**INDIANA COAL COUNCIL'S COMMENTS ON
VECTREN 2016 INTEGRATED RESOURCE PLAN**

A. INTRODUCTION. The Indiana Coal Council (“ICC”) conducted a review of the Integrated Resource Plan (“IRP”) that Southern Indiana Gas and Electric Company d/b/a Vectren Energy Delivery of Indiana, Inc. (“Vectren”) prepared and submitted to the Indiana Utility Regulatory Commission (“IURC”) on December 16, 2016. In response to Vectren’s IRP, ICC submits the comments below.

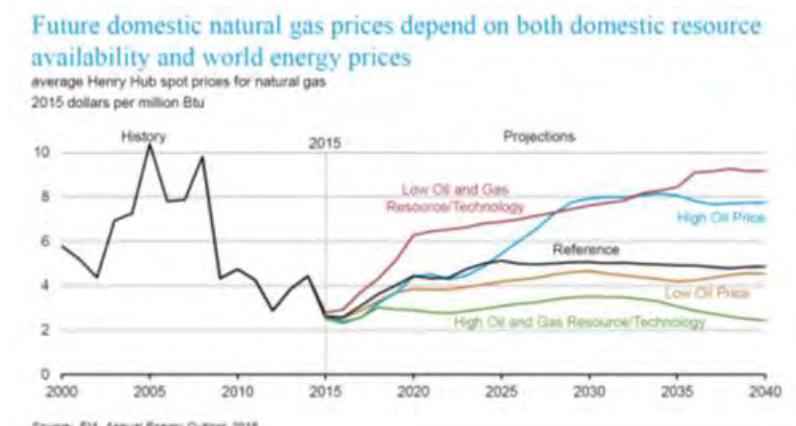
- 4.9 The need for individual scenario analysis for gas can also be seen by looking at **the Energy Information Administration’s 2016 Annual Energy Outlook for** natural gas prices.²⁵ As shown below, EIA believes that there is a significant range

²⁵ **Vectren included EIA’s historic gas price exhibit in the IRP. Vectren pointed out how shale gas has led to a large decline in natural gas prices with an implication that low prices were here to stay. Vectren did not provide EIA’s forecasts which show EIA’s belief that current prices are not believed to be sustainable and there is a wide range of outcomes with respect to future natural gas prices.**
